INFRASTRUCTURE REHABILITATION - PHASE 3

RESTAURANT KITCHEN WITH FOOD VENDING

BID ADDENDUM #3

1 MECHANICAL FIRST FLOOR CONSTRUCTION PLAN
SCALE: 1/4" = 1'-0"

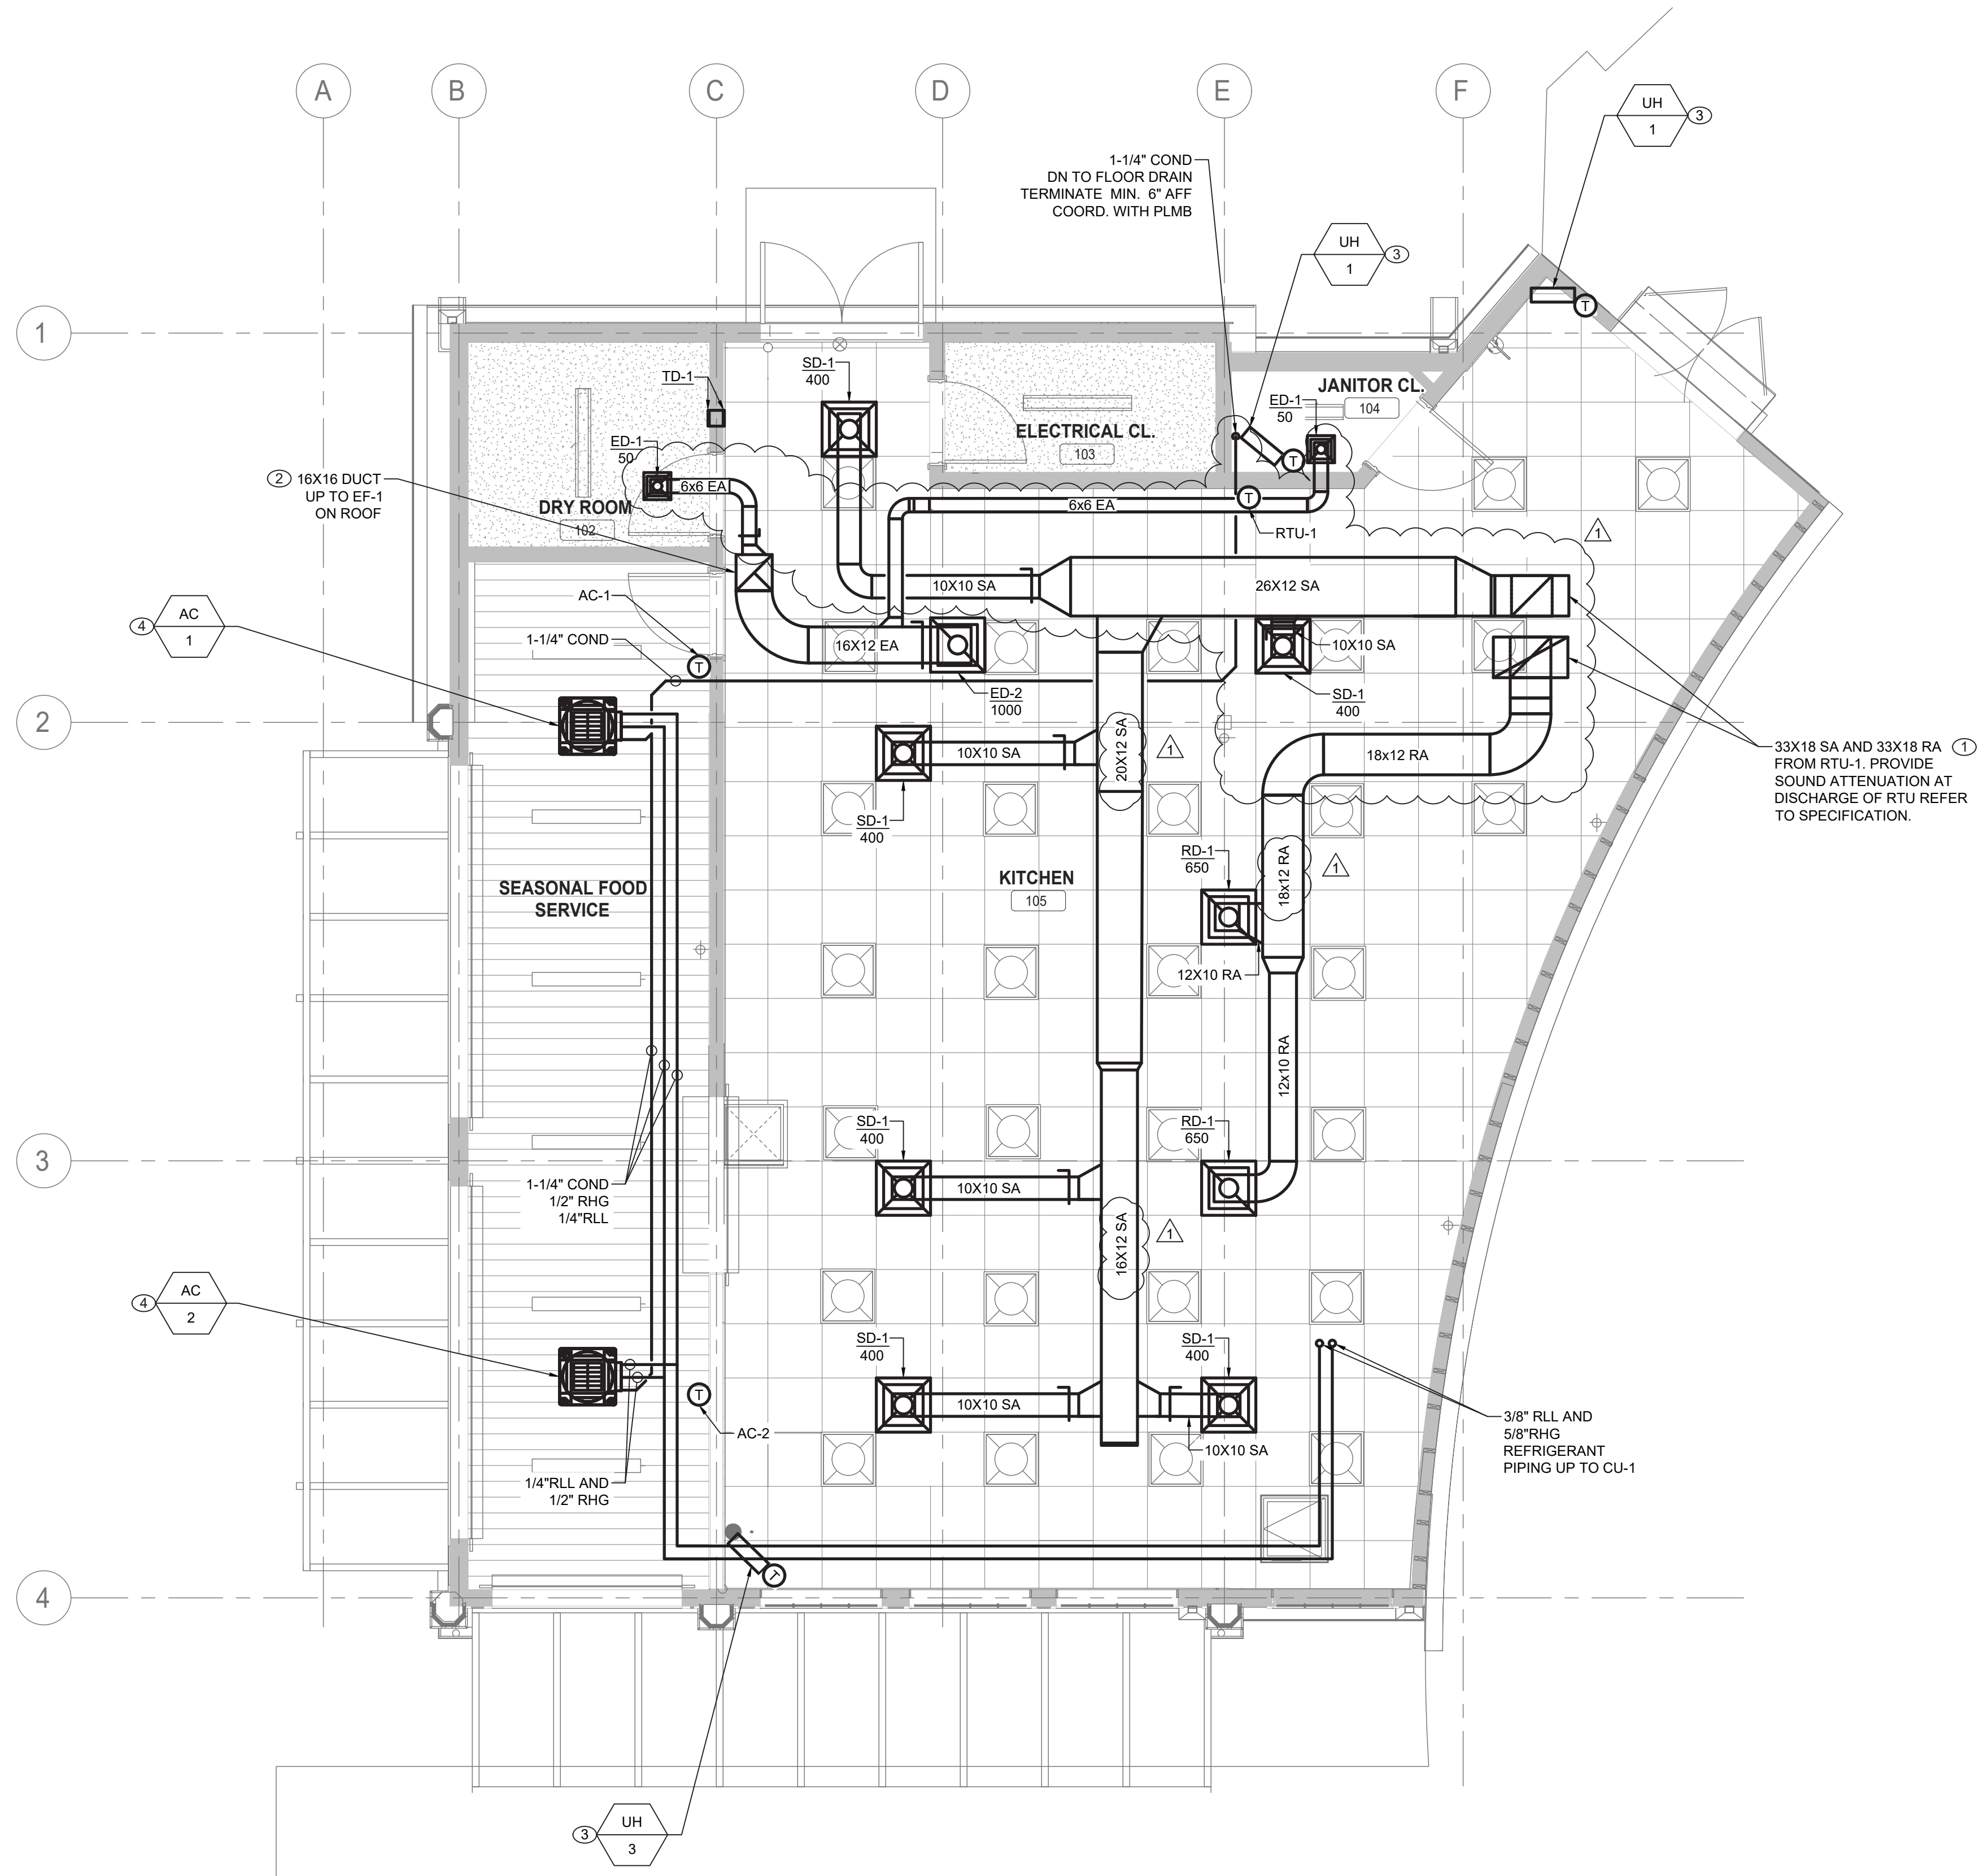
- PROVIDE SUPPLY AND RETURN DUCTWORK FROM ROOFTOP UNIT RTU-1 AND ROUTE ALONG INDICATED PATH. PROVIDE INSULATION TO ALL SUPPLY DUCTWORK. PROVIDE VOLUME DAMPERS AND SUPPLY DIFFUSERS/GRILLES AND BALANCE TO INDICATED VALUES.
- PROVIDE EXHAUST DUCTWORK FROM KITCHEN UP TO ROOFTOP EXHAUST FAN AS INDICATED.
- PROVIDE NEW WALL MOUNTED ELECTRIC UNIT HEATER. COORDINATE INSTALL HEIGHT IN FIELD.
- PROVIDE NEW CEILING MOUNTED INDOOR UNITS AC-1 AND AC-2 AS SHOWN. COORDINATE ELECTRICAL POWER AND WIRING WITH ELECTRICAL DRAWINGS.

1 MECHANICAL ATTIC FLOOR CONSTRUCTION PLAN
SCALE: 1/4" = 1'-0"

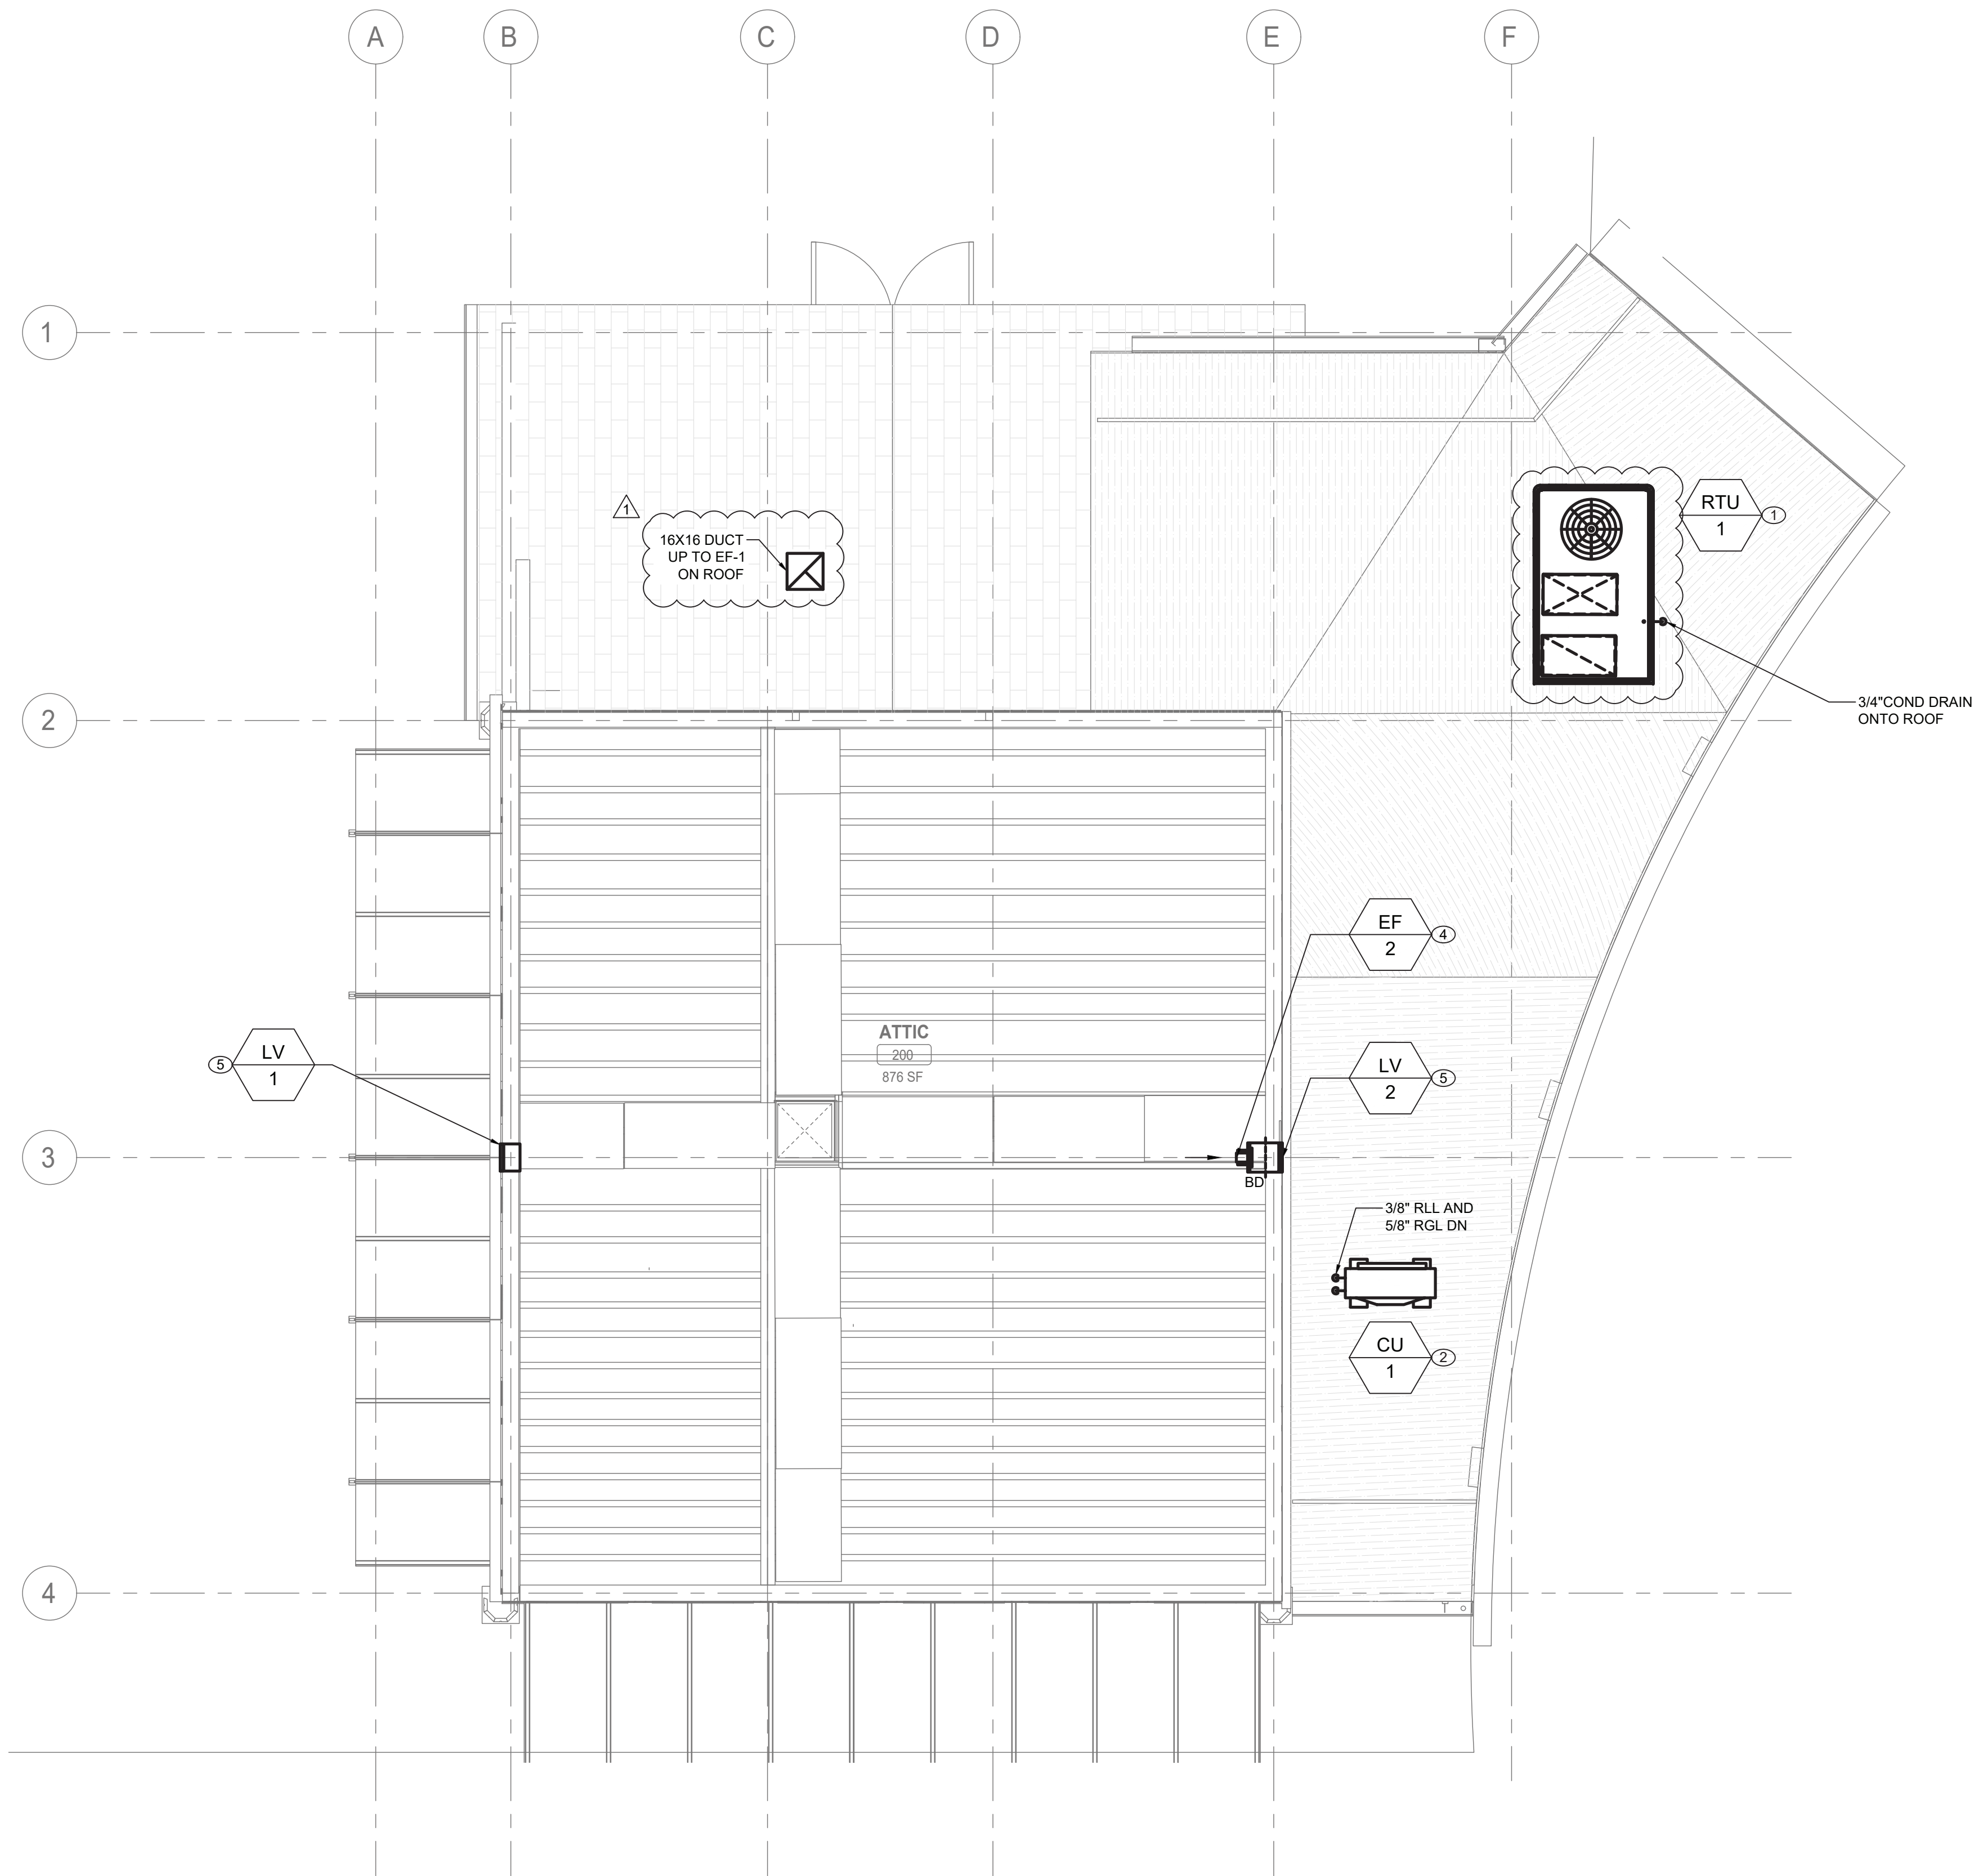
- ① PROVIDE SUPPLY AND RETURN DUCTWORK FROM ROOFTOP UNIT RTU-1 AND ROUTE ALONG INDICATED PATH. PROVIDE INSULATION TO ALL SUPPLY DUCTWORK. PROVIDE VOLUME DAMPERS AND SUPPLY DIFFUSERS/GRILLES AND BALANCE TO INDICATED VALUES. PLACE UNIT ON NEW ROOF CURB AS SHOWN ON K-M-82.
- ② PROVIDE NEW OUTDOOR SPLIT CONDENSER AIR CONDITIONER UNIT ON ROOF AS SHOWN. COORDINATE ELECTRICAL POWER AND WIRING WITH ELECTRICAL DRAWINGS. PLACE UNIT ON EQUIPMENT RAILS AS SHOWN ON K-M-81
- ③ PROVIDE NEW PACKAGED TERMINAL AIR CONDITIONER UNIT. COORDINATE ELECTRICAL POWER AND WIRING WITH ELECTRICAL DRAWINGS.
- ④ PROVIDE NEW EXHAUST FAN AS SCHEDULED. COORDINATE ELECTRICAL POWER AND WIRING WITH ELECTRICAL CONTRACTOR. INSTALL EF-2 AT 6'0" ABOVE ATTIC FLOOR TO CENTER.
- ⑤ PROVIDE NEW RAIN RESISTANT LOUVERS AS SCHEDULED. INSTALL LV-1 AND LV-2 AT 6'0" ABOVE ATTIC FLOOR TO CENTER.
